### Addendum Number 02

Project	Ramsey - Baske	etball Locker Roon	n	Dat	e 11/3	30/2021
Project Location	92 Catamount F Cullowhee, NC 2			Arc	nitect's P	roject Number 09.9478.000
Owner / Client	Western Carolin	a University		File	A2	This is page 1 of 2
То	Western Carolin	a University, Faci	lities Management	Atte	ention	Daniel Fiskeaux
Address	3476 Old Cullov	vhee Road				
City	Cullowhee			Stat	e NC	Zip 28723 Code
Delivered via:	🗌 Me	ssenger 🗌	Hand carried	☐ Facsim	ile	
	🗌 Exp	oress 🗌	Pick-up	🛛 E-mail	Address	
	🗌 Ma	ii 🗆	UPS	🗌 Websit	e Addres	S
any of the Work of all re Addendum supersede of	levant contents of thi nly those conflicting is	s Addendum. In case o sues. It is the respons	of conflicting provisions vibility of the Contractor	with previous a to notify all su	addenda o Ibcontract	nd all others performing or supplying or communications, provisions in this fors from whom it accepts bids of all Idendum number and its date in the

Addendum 02 forms a part of the Contract Documents for the above referenced project. The following specifications are revised to capture the questions in RFI1. The following drawings are added and revised to capture the questions in RFI1, updated door f

Project Name **RAMSEY - BASKETBALL** LOCKER ROOM RENOVATION Project Number 009.9478.000 Description ENLARGED PLAN, RCP & INTERIOR ELEVATIONS OF STORAGE Scale As indicated

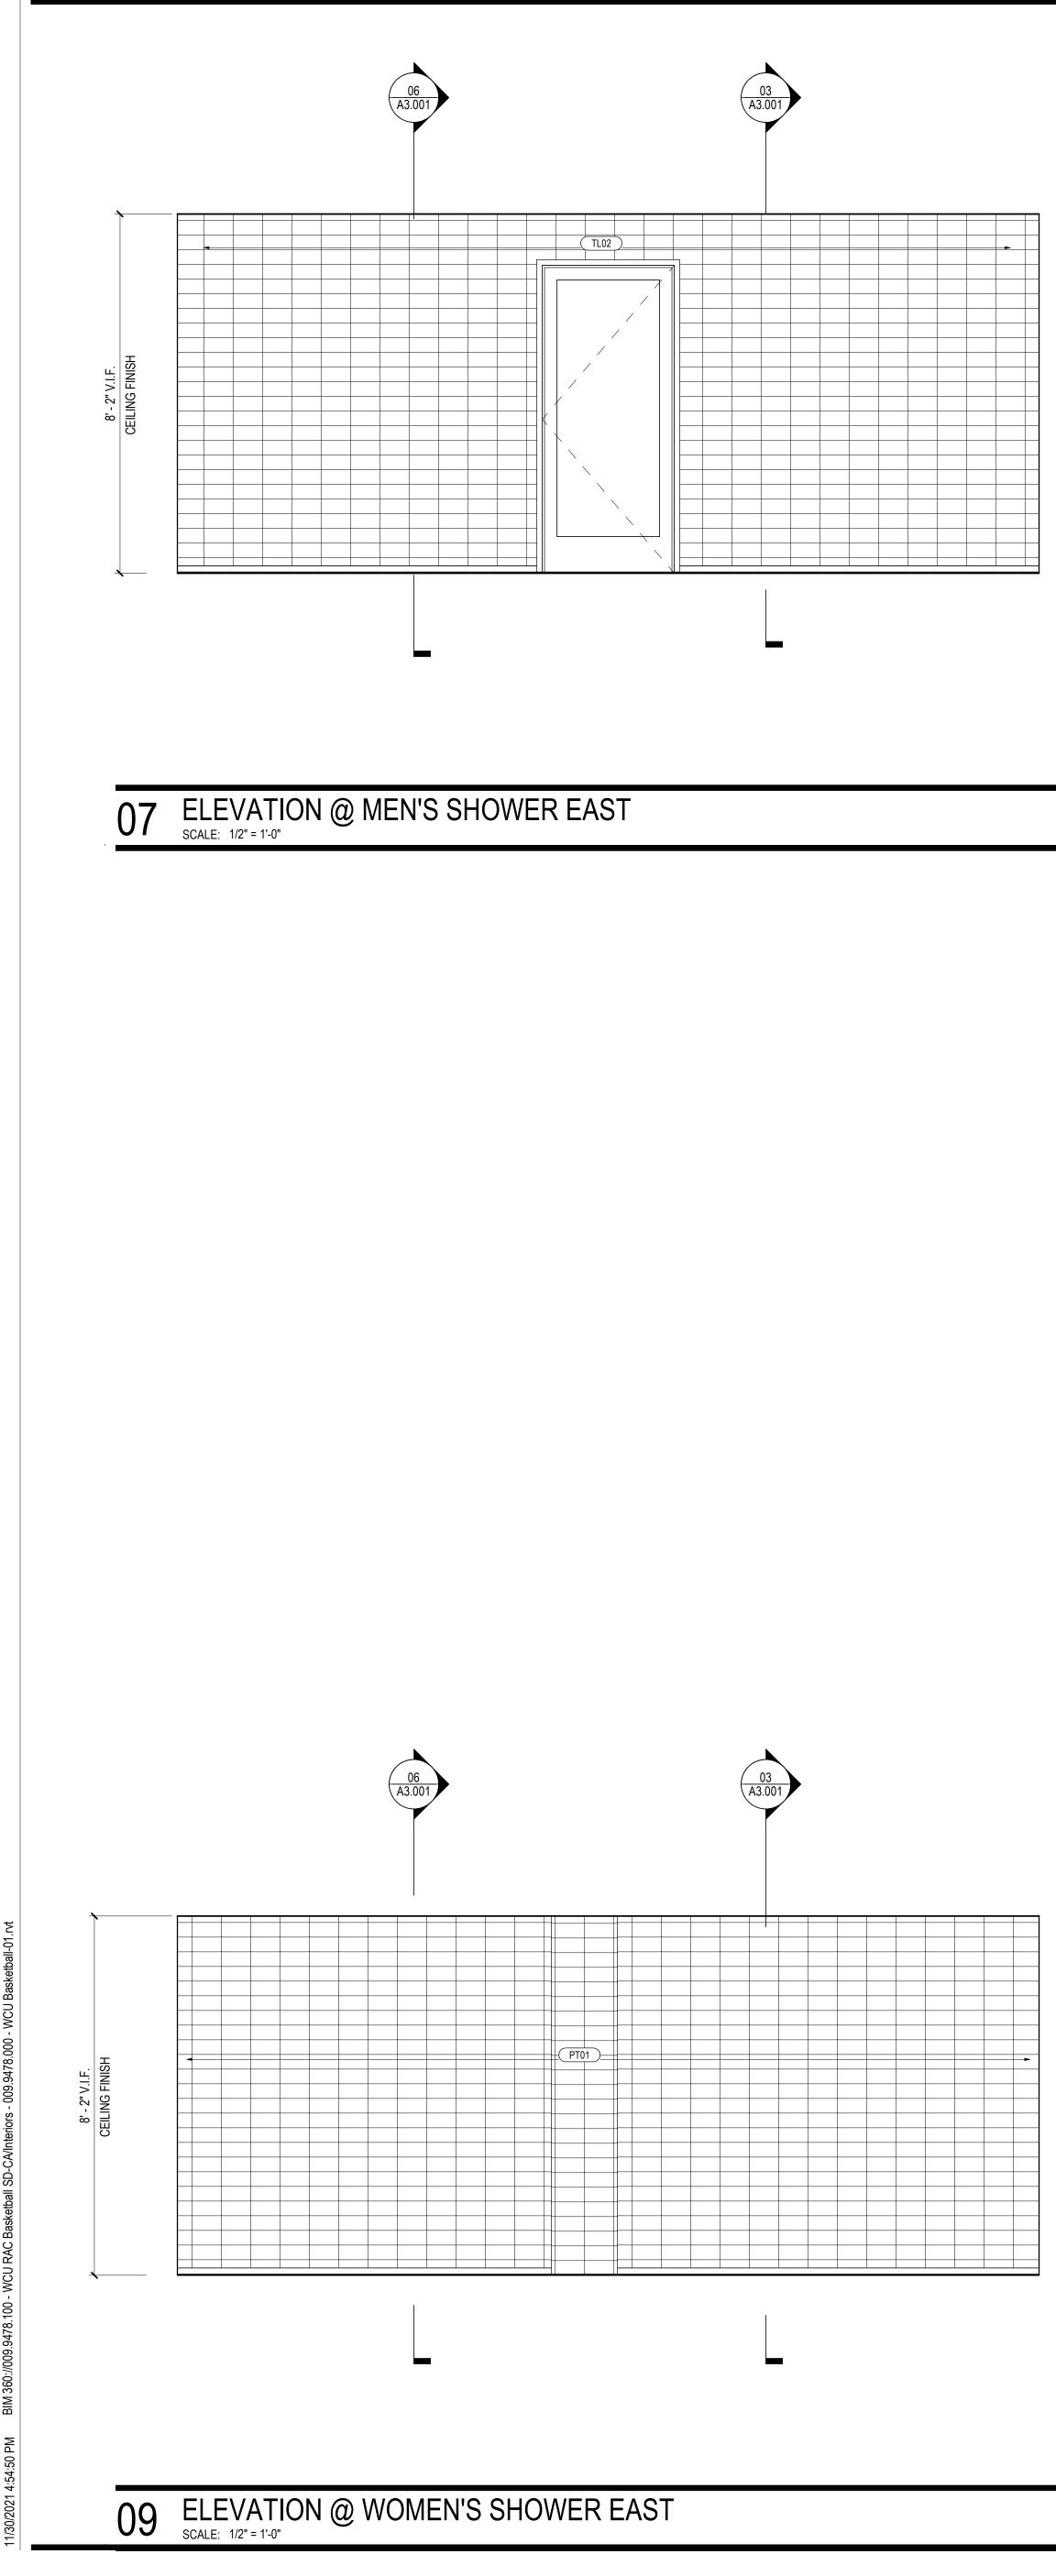
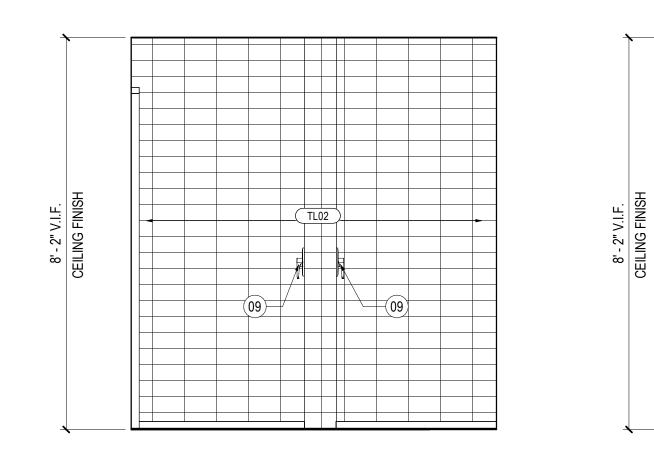
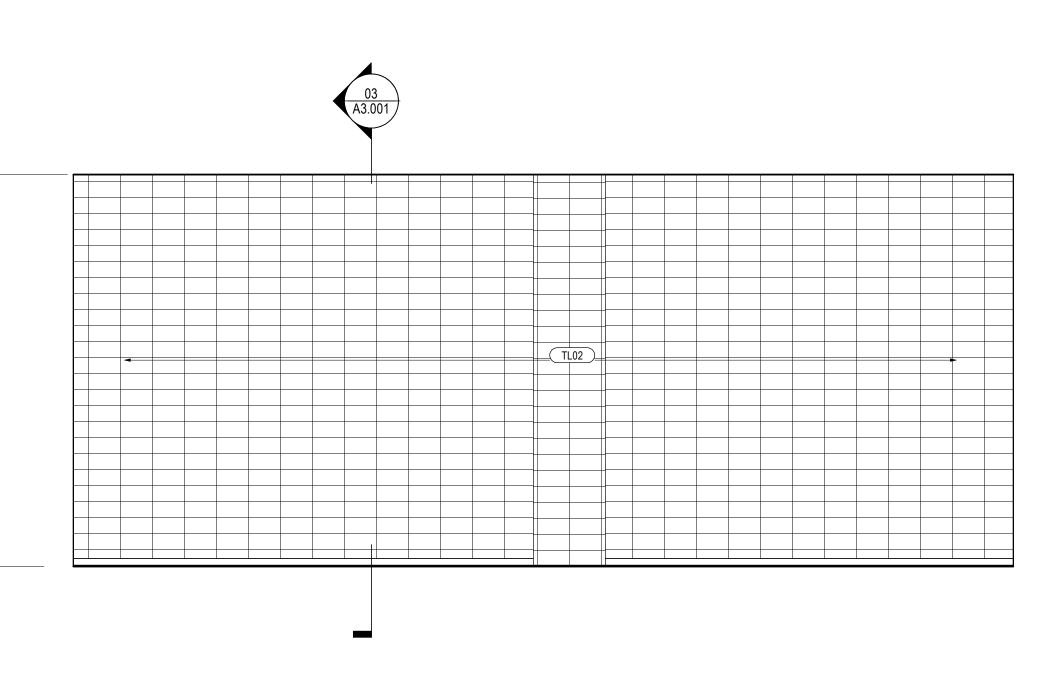
12	11/23/2021	Brantley Construction Company	There appears to be some sort of shelving or cabinetry shown at Storage Room 1420 on 02, 03, 05 & 06/11.109 but there are no notes or sections provided to explain what is required. Please clarify if shelving or cabinetry is required at this room and if so please provide additional information.	Refer to G6.02 updated schedules.	Gensler	11/30/2021	AD02
13	11/23/2021	Brantley Construction Company	There are dashed lines shown on D1.001 along 2 walls at existing rooms 1427 and 1428. Do these dashed lines represent items to be demolished? If so please provide information on these items.	Dashed lines have been removed from rooms 1427 and 1428.	Gensler	11/30/2021	AD02
14	11/23/2021	Brantley Construction Company	Please confirm that the lockers should NOT be included in the base bid.	See bid alternate 1 in Adendum 01.	Gensler	11/30/2021	AD01
15	11/23/2021	Brantley Construction Company	Please confirm that the existing toilet partitions at rooms 1424 and 1424A should be demolished and replaced with new.	Existing toilet partitions at rooms 1424 and 1424A to be replaced in kind/ like to existing.	Gensler	11/30/2021	AD02
